# Work Order ID 119098

Item Name: Crosstube Turning Detail

<b>DART AEROSPACE LTD</b>		<b>Work Order:</b>	119098
<b>Description:</b> Crosstube Assembly (205/212 High Aft)		<b>Part Number:</b>	D212-664-241
<b>Inspection Dwg:</b> D212-664-241 Rev: D		<b>Page 1 of 2</b>

DRAWING NO. D212-664-241	TITLE CROSSTUBE ASSY (205/212 HI AFT)	REV. D	<b>DART AEROSPACE LTD ENGINEERING ORDER</b>		D.E.O. NO. D212-664-241-D-1	SHEET NO. SHEET 1 OF 2	SCALE NTS
DRAWN	CHECKED		MFG. APPR.		APPROVED	DE APPR.	
DATE 11.04.07	DATE 11.04.11		DATE 11.04.12		DATE 11/04/12	DATE 11.04.12

D212-664-241/-241B  
ASSEMBLY DETAIL

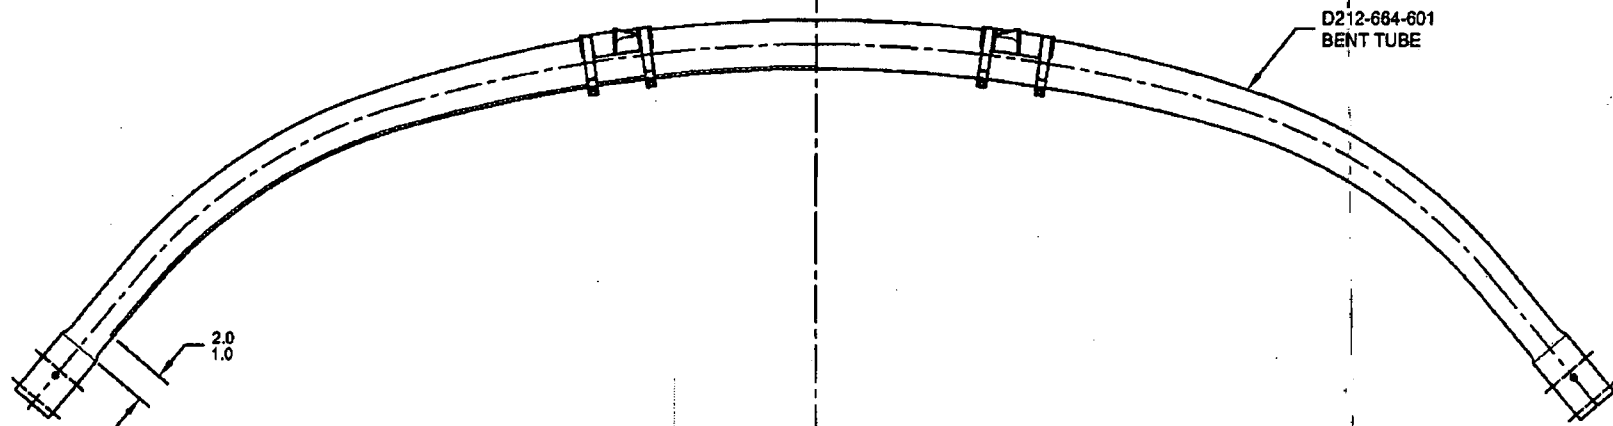
**PURPOSE:**

ADD AN INSPECTION WINDOW TO UNDERSIDE OF CROSSTUBE.

**NOTES 2 OF SHEET 1 IS AMENDED AS FOLLOWS:**

**IS:**

- 2) FINISH: CHEMICAL CONVERSION COAT PER DART QSI 005 4.1  
PRIME INSIDE AND OUTSIDE PER DART QSI 005 4.2  
MASK UNDERSIDE OF CROSSTUBE AS SHOWN (HATCHED AREA) AND  
PAINT OUTSIDE PER DART QSI 005 4.2  
REMOVE MASKING AND APPLY CLEAR COAT

**WAS:**

- 2) FINISH: CHEMICAL CONVERSION COAT PER DART QSI 005 4.1  
PRIME INSIDE AND OUTSIDE PER DART QSI 005 4.2  
PAINT OUTSIDE PER DART QSI 005 4.2

MASK AREA PRIOR TO PAINTING,  
REMOVE MASKING AFTER PAINT  
AND APPLY CLEAR COAT
